ADDENDUM NUMBER ONE

TITLE: Timber Pavilion and Parking Area Construction, DEM

NOTICE OF ADDENDUM NUMBER ONE (1)

State of Rhode Island
DEM-Planning and Development Contract No. 14-14
Bid Number 7549012
Timber Pavilion and Parking Area Construction
Great Swamp Shooting Range
West Kingston, Rhode Island

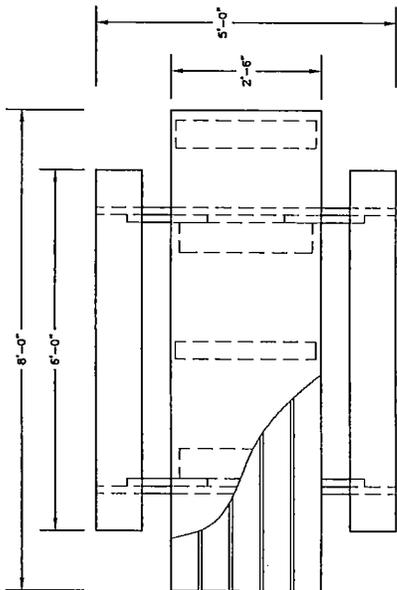
- ITEM A)** Section 13121 – Pre-Engineered Structures, Part 2 – Products, Section 2.3 - Accessories, **add** “C. The contractor shall provide six (6) cedar picnic tables on site in accordance with the provisions of the attached plan AD-1 entitled *Plan for ADA Accessible Picnic Tables*, dated October, 2014.”
- ITEM B)** Section 16210 – Solar Electric Installation, Part 2 – Products, Section 2.2 – Electric System Requirements, **add** “E. The contractor shall provide adequately sized enclosure(s), as determined by the design engineer, for the inverter(s) and battery bank meeting the standards of a NEMA 4X enclosure. All necessary enclosures shall be properly grounded and mounted on concrete foundations.”
